P0595-007
April 21, 2021

Re: Site Review Permit Application
Proposed Mixed Use Development, Raynes Avenue, Portsmouth, NH

Raynes Ave - City of Portsmouth TAC COMMENT RESPONSE Date: April 21, 2021

1 TREE PLANTING DETIAL
SCALE: 3/8"=1'-0"

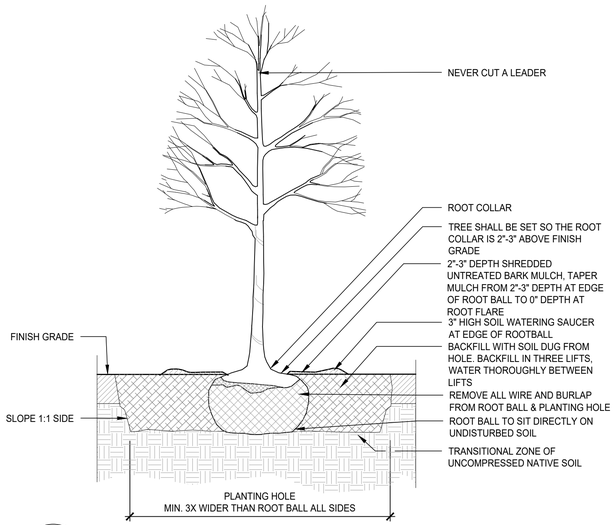
12	No tree planting specification were included as part of this plan set, please add City's tree planting details.	Tree planting details and City tree planting requirements have been added to Sheet L-102.	L-102
13	Any trees located in the City's right-of-way will require review and approval by the City's Trees & Greenery Committee.	Agreed.	L-101
14	Serious consideration should be given to converting the entire length of Raynes Ave and Vaughan Street to one-way counterclockwise flow, due to narrowness of road, delivery trucks loading zones and parking on both sides, and corner radii at driveway. Otherwise, the road would need to be widened to accommodate improved two-way flow with the increase in traffic flow and on-street parking demand created by the density of uses.	The applicant is agreement that Raynes Avenue be converted to a one-way road and the Site Plan has been revised to show this.	C-102.1

CITY RIGHT-OF-WAY PAVEMENT SECTION
NO SCALE

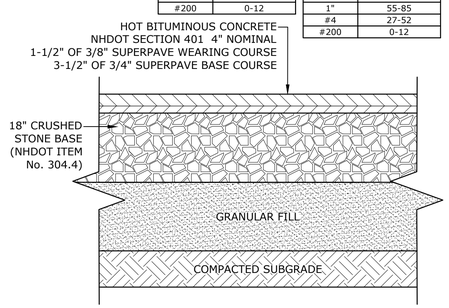
44	Use 18" of 304.4 under pavement and sidewalks.	The details have been revised to use 18" of 304.4 under the City pavement section and 8" of 304.4 under sidewalks.	C-502 & C-503
45	Do not use wire reinforcement in any City owned sidewalks, use poly fiber mesh instead	Sidewalk detail has been revised to include poly fiber mesh.	C-503
46	City CB's need liners, please add to detail	Polyethylene liner detail has been added to the plan.	C-504
47	Maintenance of the stormwater system needs to happen at least yearly with reports to DPW	As stated in section 7.6 of the Drainage Analysis, Copies of the Stormwater Maintenance report shall be submitted to the City of Portsmouth on an annual basis	N/A
48	Provide a higher (24') North End light pole for Raynes Maplewood Intersection like Vaughn/Maplewood existing pole	The pole at the corner of Raynes and Maplewood has been revised to a 24' pole.	C-102.1

RAPID RECTANGULAR FLASHING BEACON (RRFB)
NO SCALE

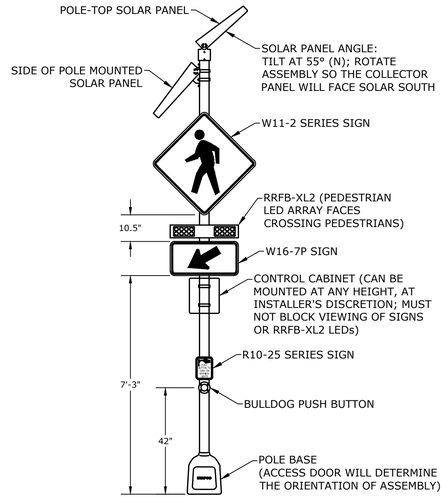
15	Crosswalk across Maplewood Ave should have RRFB installed due to volume and speed of traffic, and limited sight lines.	Rectangular Rapid-Flashing Beacons (RRFB) have been added to the crosswalk signage at the Maplewood Ave crosswalk location.	C-102.1
16	Signs on sidewalks should be at least 7'3" to provide clearance for sidewalk plow.	Sign post detail has been revised to provide 7'-3" clearance.	C-503
17	Bike racks seem to be far away from any entrance. Any place closer to a doorway would be preferable.	Bike storage for the residential building will be located inside the building. The bike racks shown at the entrance to the North Mill Pond trail are intended to be used by the public when utilizing the trail. The bike racks for the hotel are located under the covered area of the hotel entrance near the stairwell exit and in the proximity of the hotel drop off, but in an area that does not interfere with the loading/unloading operations of the hotel.	C-102.1
